ENGINE - AIR - INTRODUCE A NEW LPC BLEED MASTER ACTUATOR FEATURING A LINEAR VARIABLE DIFFERENTIAL TRANSFORMER (LVDT) WITH IMPROVED WIRE TERMINATION - CATEGORY CODE 4, 7 - MOD.ENG-75-0041

ENGINE COMPRESSOR CONTROL - LPC BLEED -
MASTER ACTUATOR - INTRODUCTION OF
LINEAR VARIABLE DIFFERENTIAL TRANSFORMER
(LVDT), WITH IMPROVED WIRE TERMINATION

(IAE SB V2500-ENG-75-041, Revision 1)
(LUCAS ENGINE SYSTEMS MOD. D.TV.050)

LVDT Output Voltage Checks
Figure 2

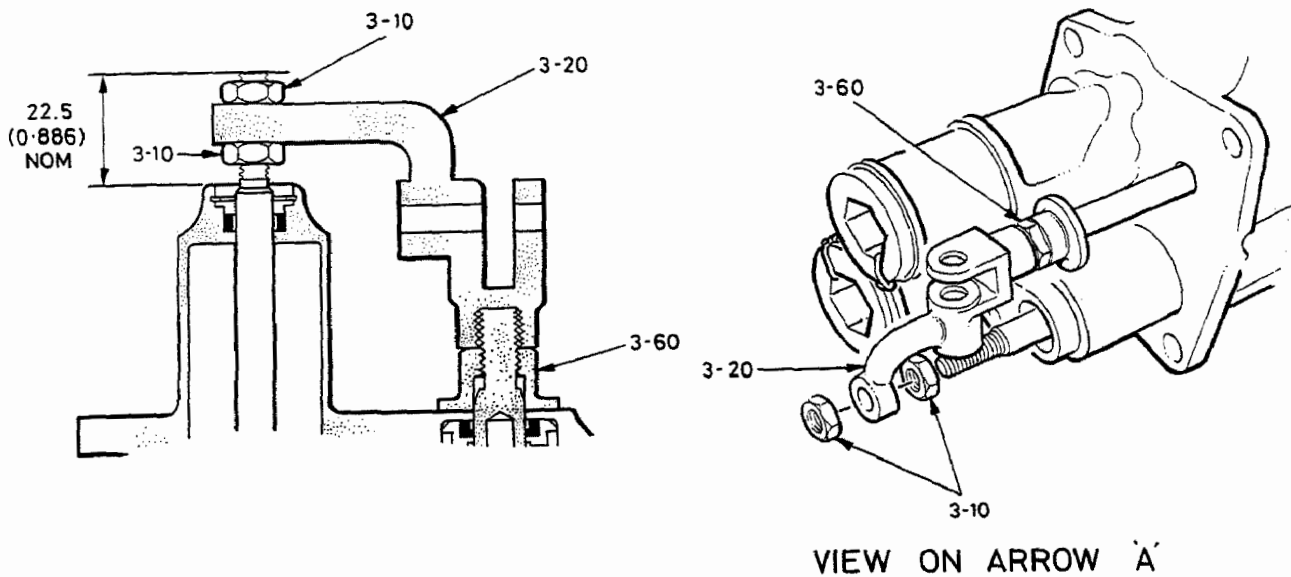
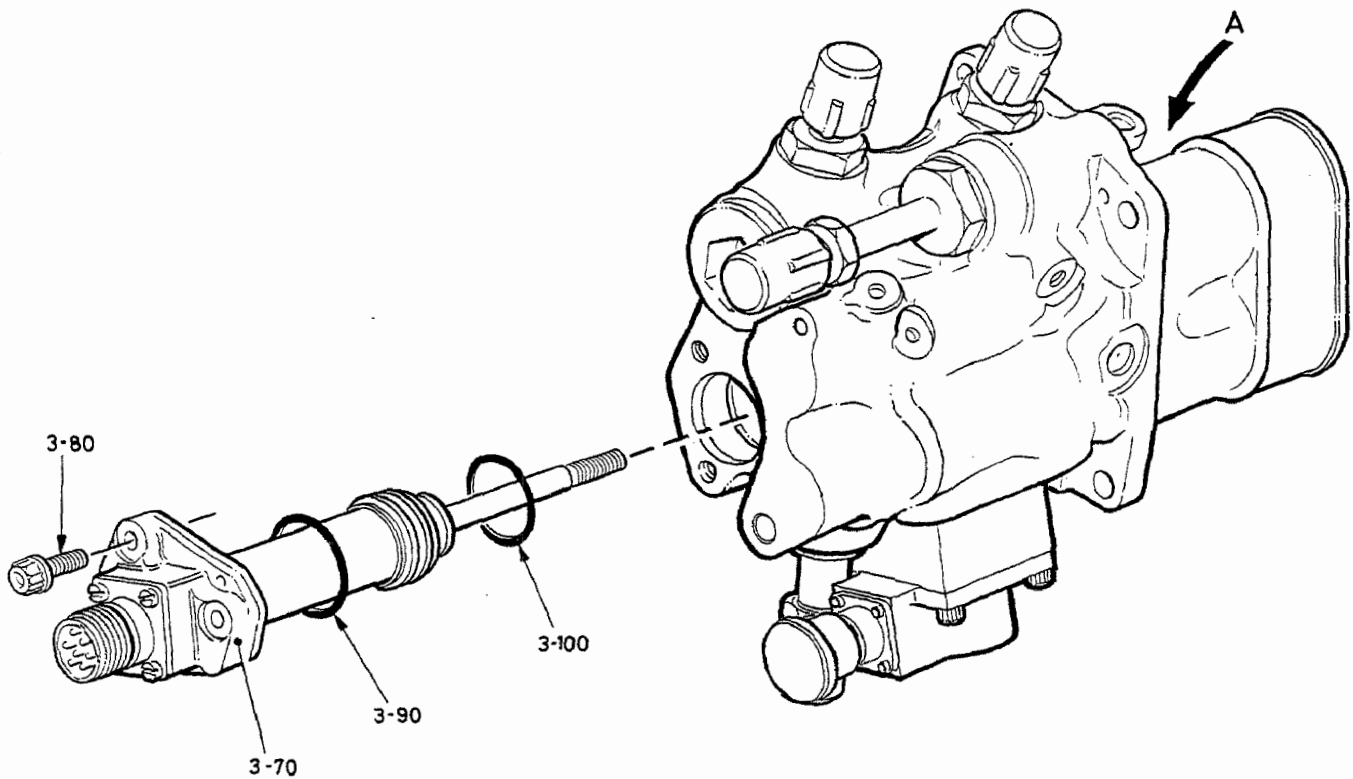
- (5) Check the local electrical supply voltage (120v or 240v). Refer to Figure 2 and set the voltage selector switch on the LVDT indicator unit EL4049, to equal the supply voltage. Connect the indicator unit to the mains supply and switch the on/off switch to the ON (down) position.

- (9) Check the LVDT Adjustment, Figure 2.
- (a) Connect the cable assembly to the socket on the LVDT indicator unit (EL4049), and the LVDT connector on the Actuator unit.

- (b) If necessary, adjust the energising voltage to $6.000 \pm 0.005\text{v}$ by means of the 6v adjustment potentiometer on the indicator unit; check that the winding switch is in the PRIMARY position and the channel switch is in the CHANNEL 1 position.
- (c) Move the ram piston (3-150) to the fully retracted position (with the flanged nut (3-60) in contact with the face of the actuator body).
- (d) Turn the winding switch to the SECONDARY position and read the LVDT output voltage on the indicator panel. Write the indicated voltage down under the heading CHANNEL 1 - Retracted (for future reference).
- (e) Turn the channel switch to the CHANNEL 2 position and repeat sub. para. (d). Write the indicated voltage down under the heading 'Channel 2 - Retracted'.

- (f) Adjust the position of the stem of the LVDT to obtain a nominal output voltage of 2.870v (use Channel 1 voltage only). Tighten the lock nuts (3-10), hand tight only.

- (g) Move the ram piston (3-150) to approximately the mid stroke position and then back to the retracted position; check that the voltages are within the limits of 2.816 to 2.930v.

- (h) Move the ram piston (3-150) to the extended position and place a 19,05mm (0.750in.) slip gage against the actuator body, between the actuator body and the flanged nut (3-60); move the ram piston in the retract mode until the flanged nut just contacts the slip gage. Hold the ram piston in this position and check the LVDT output voltages (Channel 1 and Channel 2); both voltages must be within the limit of 1.438 to 1.552v.

- (i) Remove the slip gage and move the ram piston (3-150) (by hand) to the fully extended position. Check the LVDT output voltages (Channel 1 and Channel 2), at this position; both voltages must be within the limit of 0.470 to 0.584v.

- (j) If the LVDT output voltages (Channel 1 and Channel 2), are within the limits given in sub. paras. (9) (g), (h) and (i), torque tighten the two lock nuts (3-10) to 12 Nm (105 lbf. in.), against the fork end (3-20). Repeat the voltage check for the retracted position as given in sub. para. (9) (c) thru. (e), to make sure that the stem of the LVDT did not move when the lock nuts (3-10) were torque tightened.

Removal and Installation of the LVDT
Figure 1

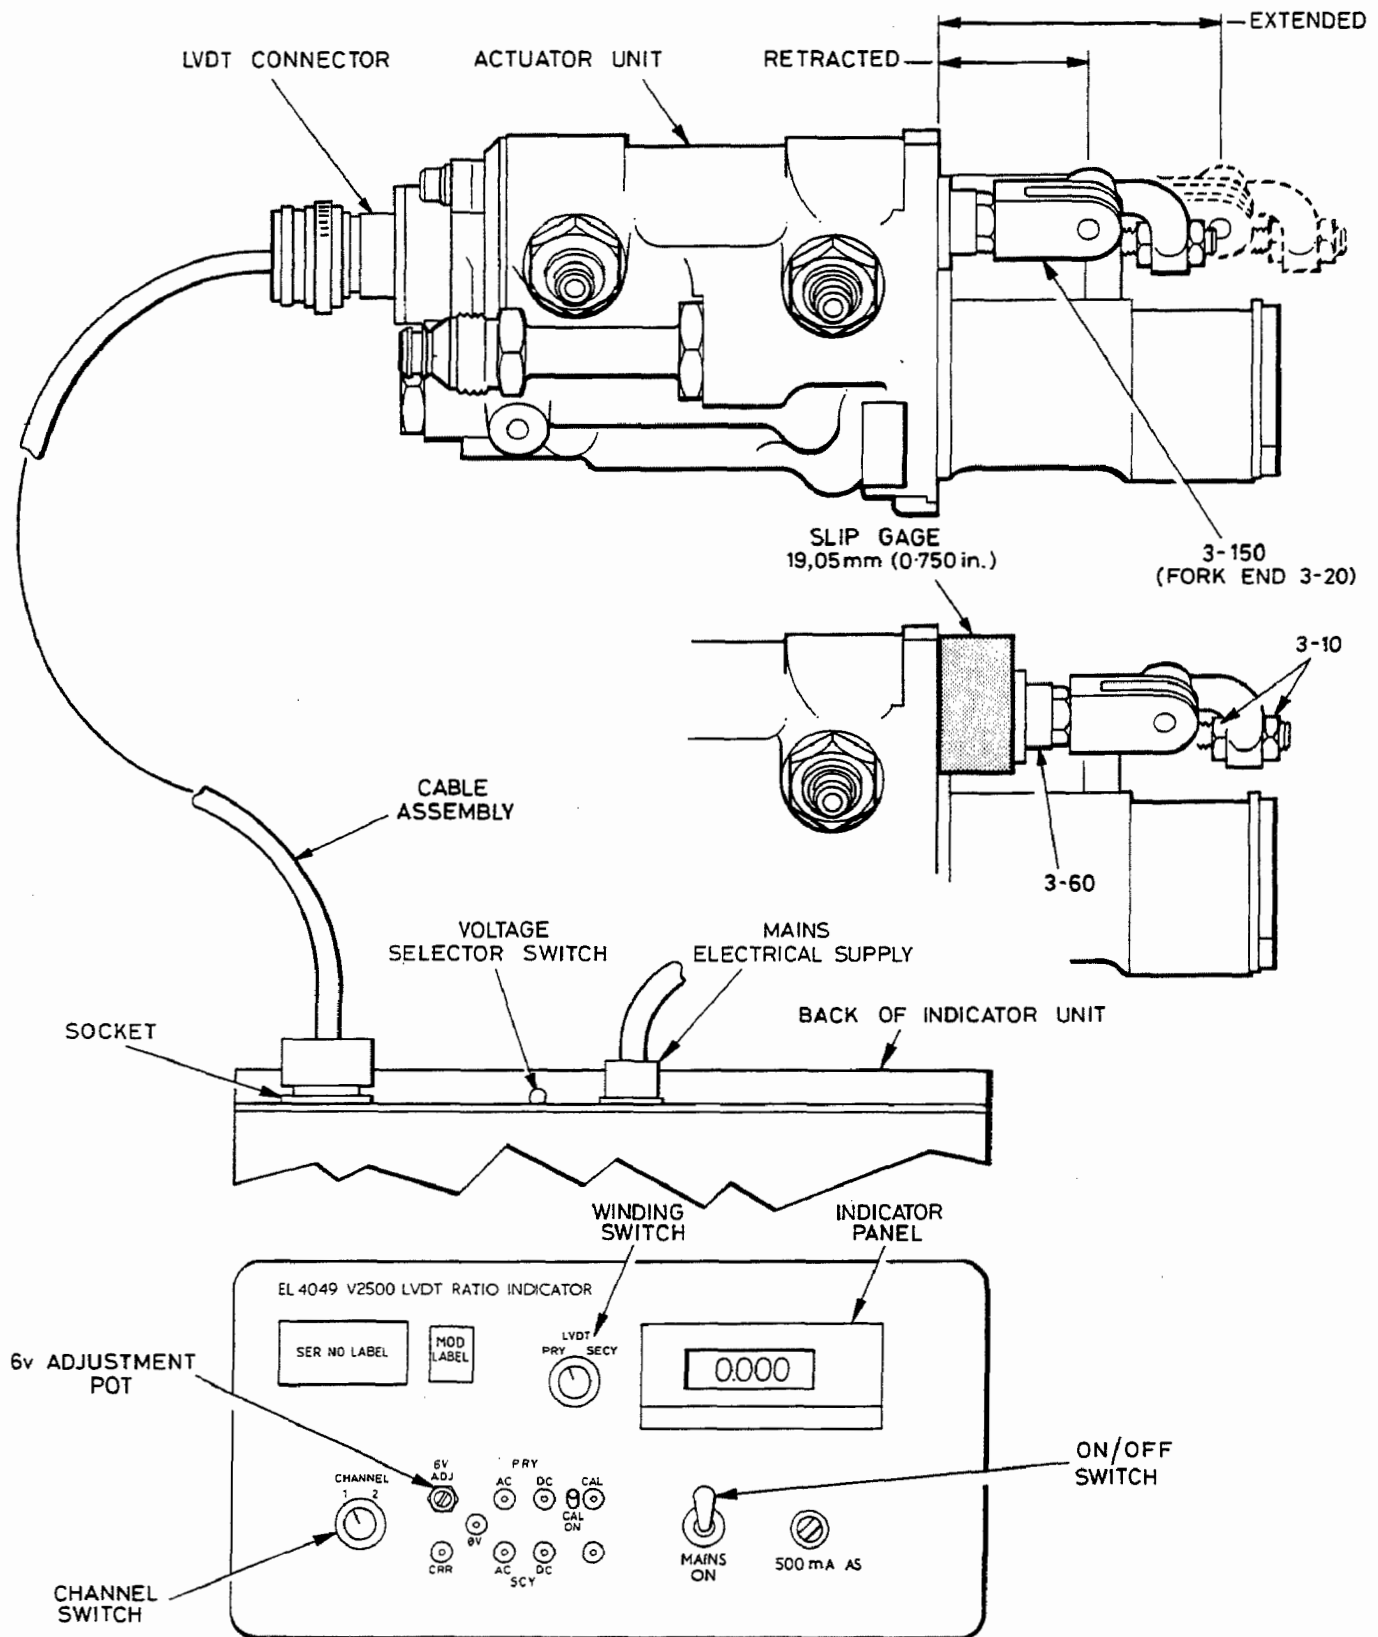
- (7) Remove the LVDT, Figure 1.

- (a) Extend the actuator jack piston (3-150) by hand to approximately the mid-stroke position.
- (b) Remove the lockwire and slacken the two locknuts (3-10) which secure the stem of the LVDT (3-70) to the fork end (3-20). Remove the outer locknut (3-10) completely.
- (c) Remove the three machine bolts (3-80) which secure the LVDT flange to the actuator body. Withdraw the LVDT until the stem of the LVDT is clear of the fork end (3-20) and remove the second (inner), locknut (3-10) from the LVDT stem; remove the LVDT from the actuator body.
- (d) Remove the toroidal sealing rings (3-90) and (3-100) from the LVDT; discard the sealing rings.
- (e) Attach a label to the removed LVDT; the label must contain this data:

- (8) Install the Replacement LVDT, Figure 1.

- (d) Get the replacement toroidal sealing rings STD1031-4121, (3-90) and STD1031-4120, (3-100); remove the sealing rings from the protective packages and assemble them to the LVDT. Make sure the seals are not twisted in the grooves.

- (e) Position the ram piston (3-150) to approximately the mid stroke position. Extend the stem of the LVDT (3-70) and install the LVDT to the actuator body. When the stem (of the LVDT), comes through the hole in the actuator body, assemble one locknut (3-10) to the stem before the stem goes through the hole in the fork end (3-20). Assemble the second lock nut (3-10) to the LVDT stem, but do not tighten the locknuts at this stage.

- (f) Align the three holes in the flange of the LVDT with the three holes in the actuator body and assemble the three machine bolts (3-80).
 - (g) Check, when the machine bolts are tightened, that there is a minimum of 0,23 Nm (2 lbf.in.) inbuilt torque in each of the inserts. If the inbuilt torque is less than this figure, reject the unit for Repair. Torque tighten the machine bolts to 4,5 Nm (40 lbf.in.).

- (h) Move the jack piston (by hand) to the fully retracted position (with the flanged nut (3-60) in contact with the face of the actuator body). By adjustment of the two lock nuts (3-10), set the stem of the LVDT to the dimension shown in Figure 1; use a vernier calliper or depth gage to measure the standout. Tighten the lock nuts (3-10), hand tight only.

LVDT Output Voltage Checks
Figure 2

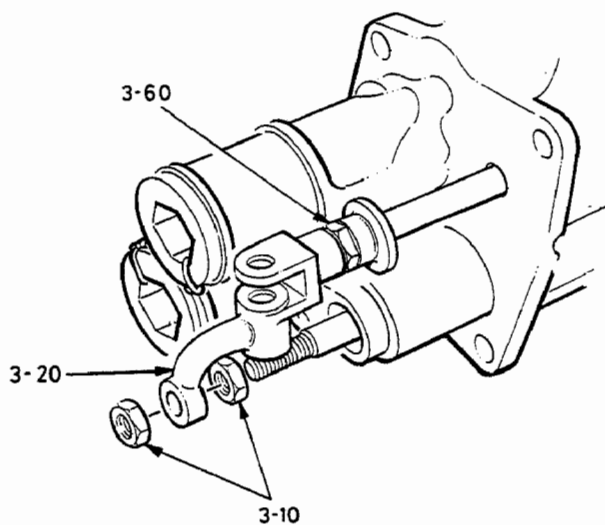
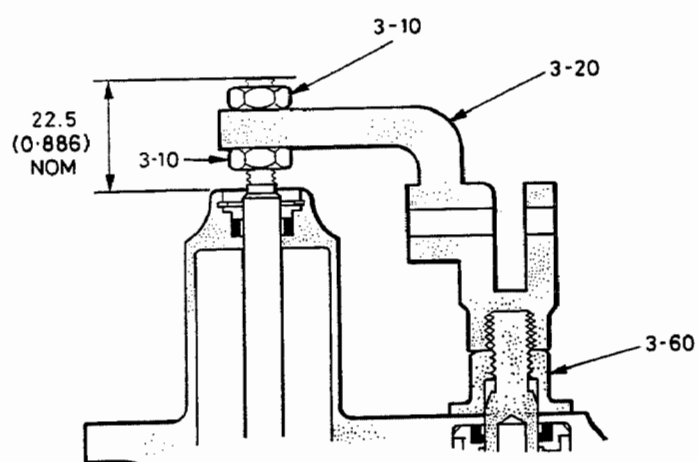
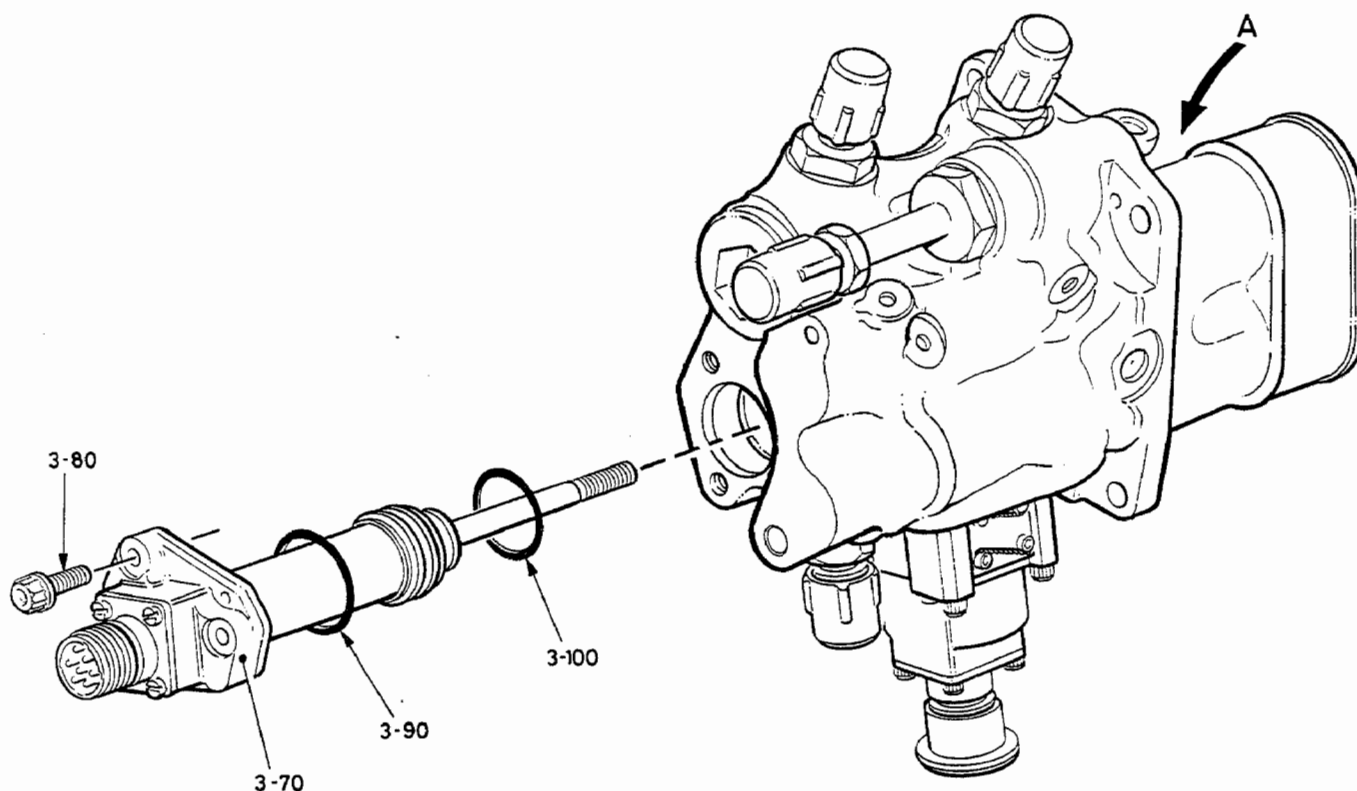
- (5) Check the local electrical supply voltage (120v or 240v). Refer to Figure 2 and set the voltage selector switch on the LVDT indicator unit EL4049, to equal the supply voltage. Connect the indicator unit to the mains supply and switch the on/off switch to the ON (down) position.

- (9) Check the LVDT Adjustment, Figure 2.
- (a) Connect the cable assembly to the socket on the LVDT indicator unit (EL4049), and the LVDT connector on the Actuator unit.

- (i) Remove the slip gage and move the ram piston (3-150) (by hand) to the fully extended position. Check the LVDT output voltages (Channel 1 and Channel 2), at this position; both voltages must be within the limit of 0.470 to 0.584v.

Removal and Installation of the LVDT
Figure 1

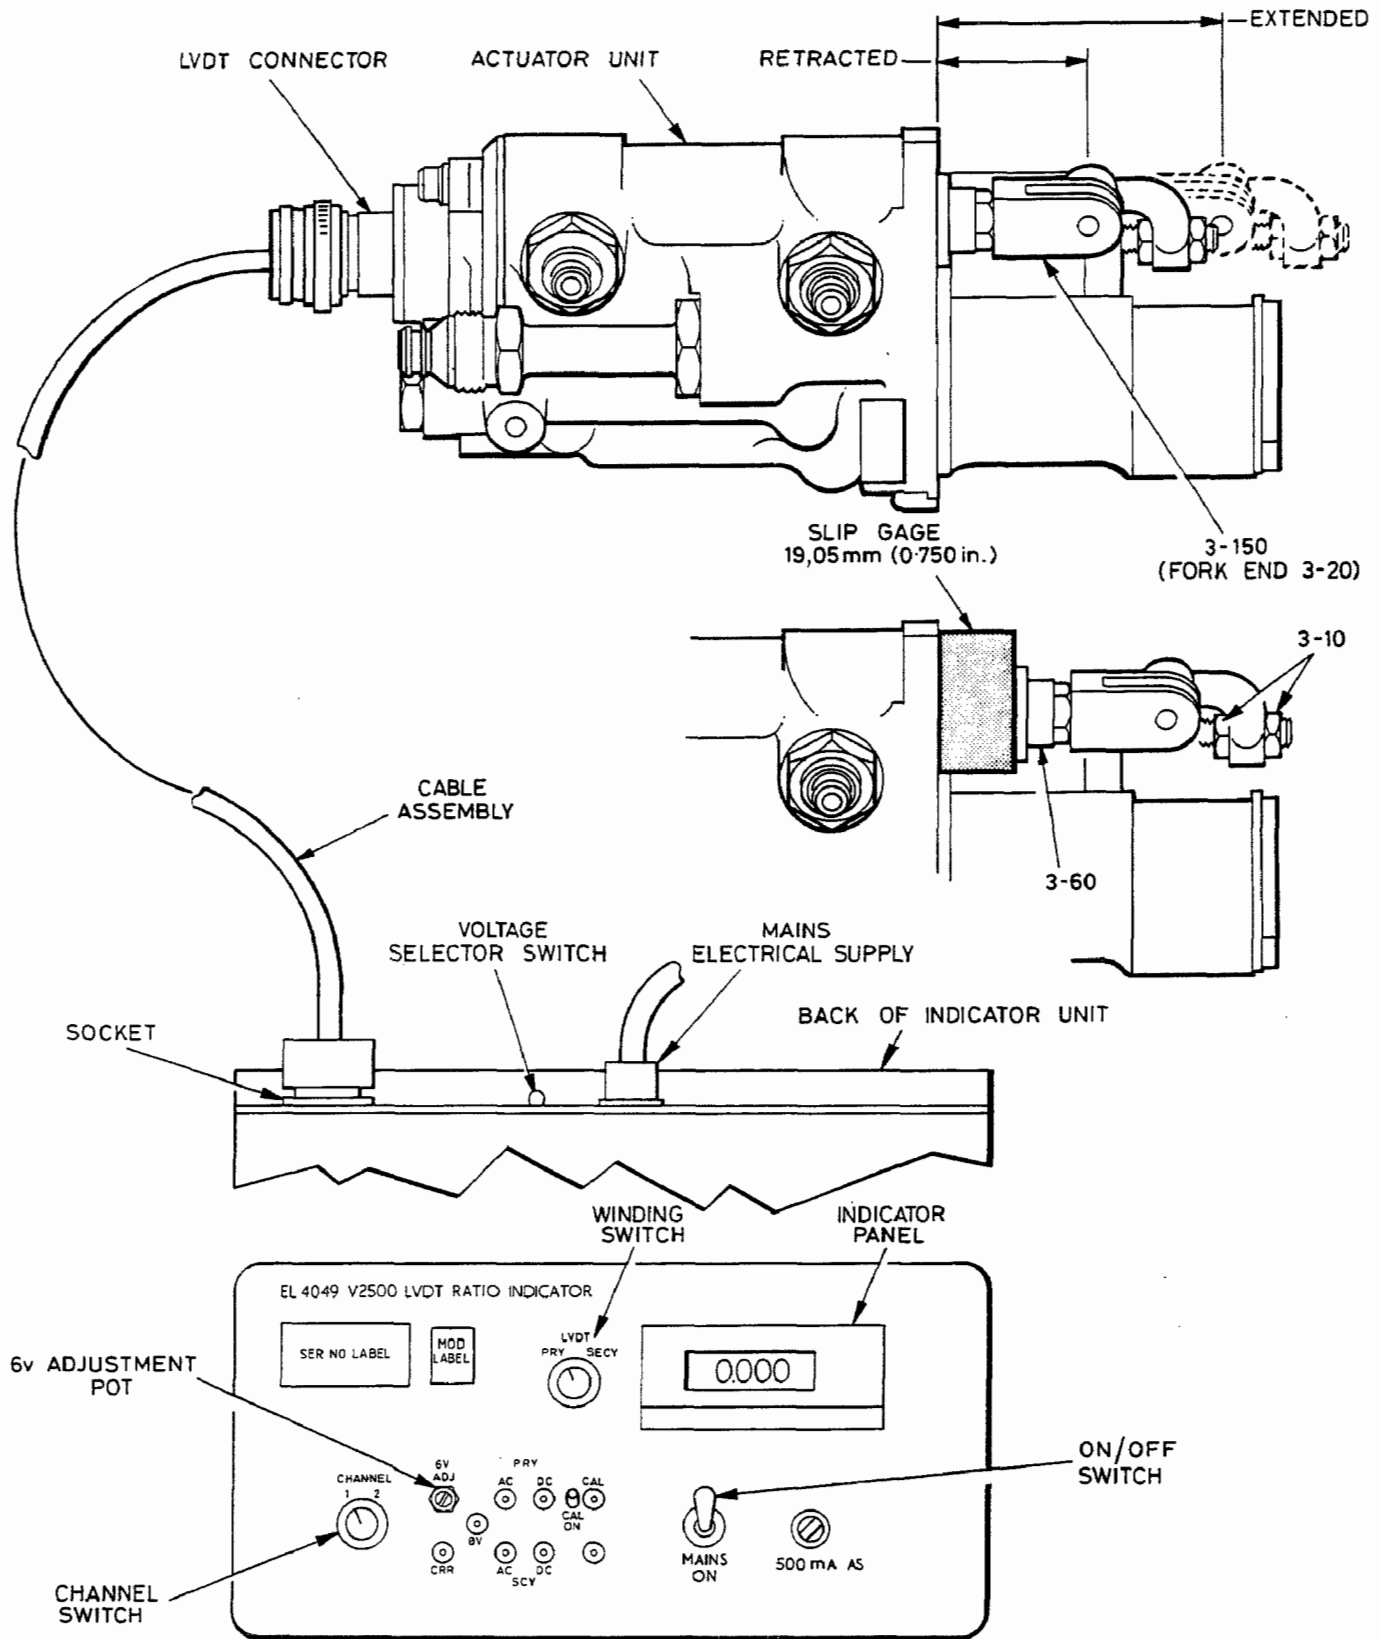
- (7) Remove the LVDT, Figure 1.

- (a) Extend the actuator jack piston (3-150) by hand to approximately the mid-stroke position.
- (b) Remove the lockwire and slacken the two locknuts (3-10) which secure the stem of the LVDT (3-70) to the fork end (3-20). Remove the outer locknut (3-10) completely.
- (c) Remove the three machine bolts (3-80) which secure the LVDT flange to the actuator body. Withdraw the LVDT until the stem of the LVDT is clear of the fork end (3-20) and remove the second (inner), locknut (3-10) from the LVDT stem; remove the LVDT from the actuator body.
- (d) Remove the toroidal sealing rings (3-90) and (3-100) from the LVDT; discard the sealing rings.
- (e) Attach a label to the removed LVDT; the label must contain this data:

- (8) Install the Replacement LVDT, Figure 1.

- (d) Get the replacement toroidal sealing rings STD1031-4121, (3-90) and STD1031-4120, (3-100); remove the sealing rings from the protective packages and assemble them to the LVDT. Make sure the seals are not twisted in the grooves.

- (f) Align the three holes in the flange of the LVDT with the three holes in the actuator body and assemble the three machine bolts (3-80).
 - (g) Check, when the machine bolts are tightened, that there is a minimum of 0,23 Nm (2 lbf.in.) inbuilt torque in each of the inserts. If the inbuilt torque is less than this figure, reject the unit for Repair. Torque tighten the machine bolts to 4,5 Nm (40 lbf.in.).

- (h) Move the jack piston (by hand) to the fully retracted position (with the flanged nut (3-60) in contact with the face of the actuator body). By adjustment of the two lock nuts (3-10), set the stem of the LVDT to the dimension shown in Figure 1; use a vernier calliper or depth gage to measure the standout. Tighten the lock nuts (3-10), hand tight only.
